# SIMTA Intermodal Terminal Facility- Stage 1

## Response to Submissions - Visual Impact Addendum

**ATTENTION** Westley Owers – Hyder Consulting  
**SENDER** Reid Campbell  
**DATE** 03/09/2015  
**PROJECT NUMBER** 112110  
**SUBJECT** Addendum to Visual Impact Assessment – Amended Rail link

Figure 1: Amended Rail link and overview of the Proposal

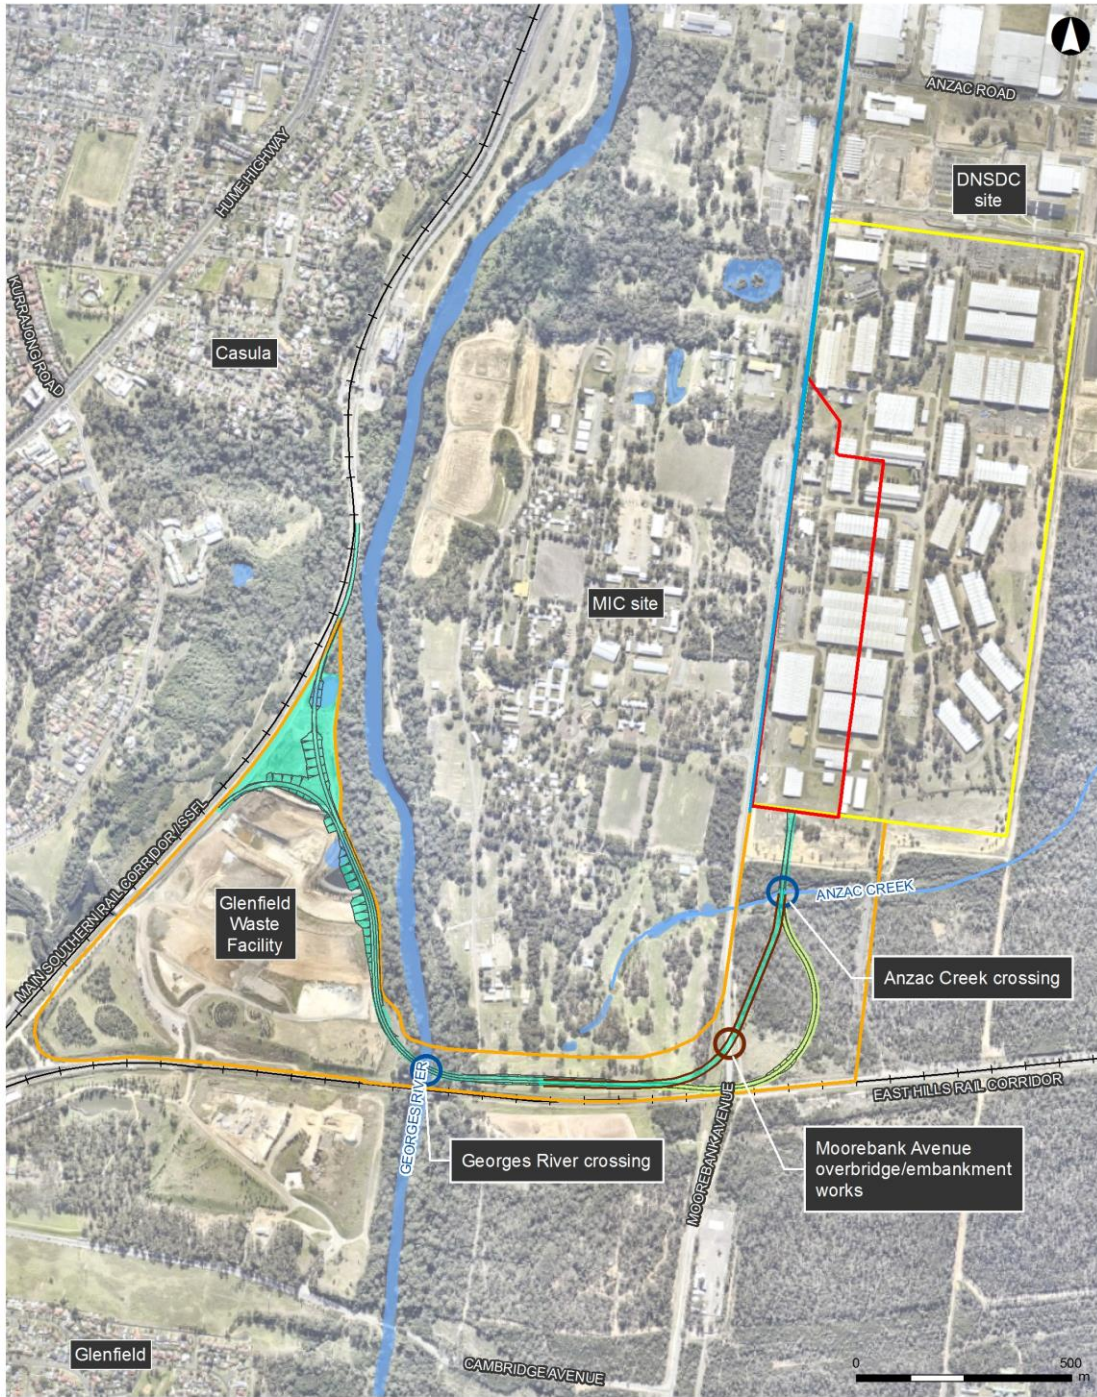
The Rail link is to be realigned within Commonwealth Land (including MIC Site, Moorebank Avenue and the Southern Boot Land) to respond to submissions (received during the exhibition of the EIS (28 May 2015 and 26 June 2015)) and also to reduce the overall environmental impacts of the Proposal (refer to Figure 1).

This realignment would alter the Rail link alignment to the south of the Anzac Creek Crossing, at the intersection with Moorebank Avenue and also on the MIC site (to the immediate west of Moorebank Avenue). The rail alignment would retain the 20 metre width of the Rail Link Corridor within environmentally sensitive areas, as per the Concept Plan Approval (MP 10\_0193) and the EIS.

This alteration in the rail alignment would result in Moorebank Avenue being intersected by Rail link further north of that previously identified within the EIS. An alteration would be undertaken to the existing Moorebank Avenue road embankment to create an overbridge to accommodate the realigned Rail link.

**Figure 2: Amended Rail link and key views**

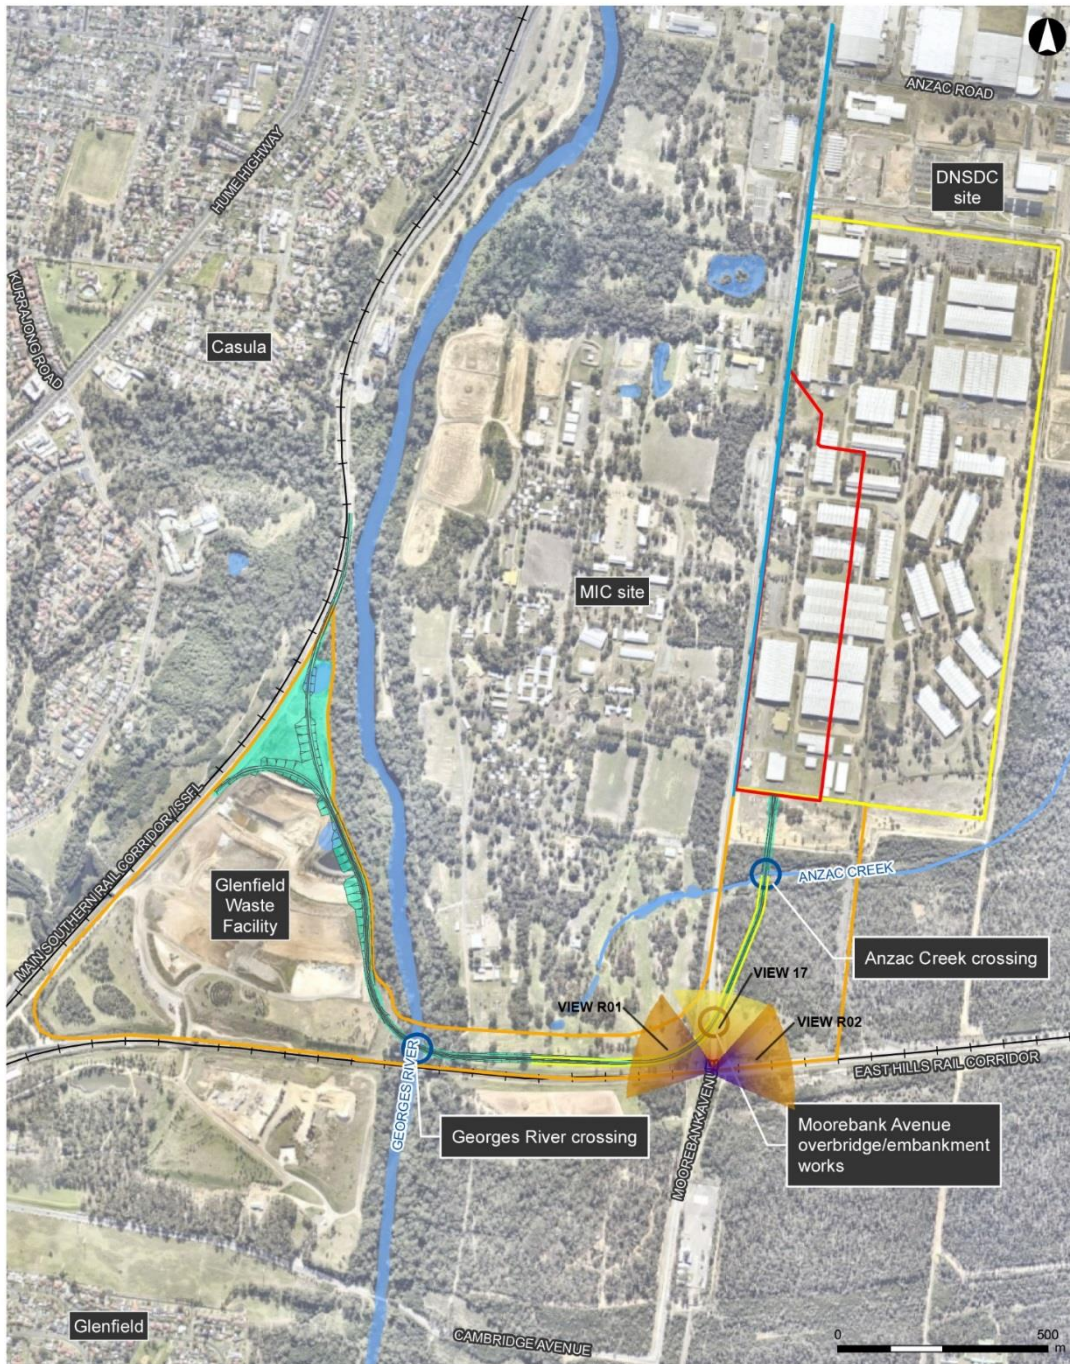
The following views (refer Figure 2 and below) have been identified to best reflect the potential impacts of the amended Rail link and allow for assessment of its visual sensitivity:

This View has unobstructed views of the existing city rail passenger line. The VIA determined that the Proposal would have a ‘Moderate’ impact on this location, a publically accessible yet privately owned road. The amendment to the proposed Rail link would entirely remove the development from view at this location. As a result, the VIA’s previous outcome predicting a ‘Moderate’ impact for the area has now been downgraded to ‘No Impact’.

The proposed amendment to the Rail link would result in similar impacts for View 17 and View R01 to that provided within the VIA. The amendment to the Rail link would considerably reduce the impacts of the Proposal on View R02. On this basis the mitigation measures provided within the VIA are considered suitable.
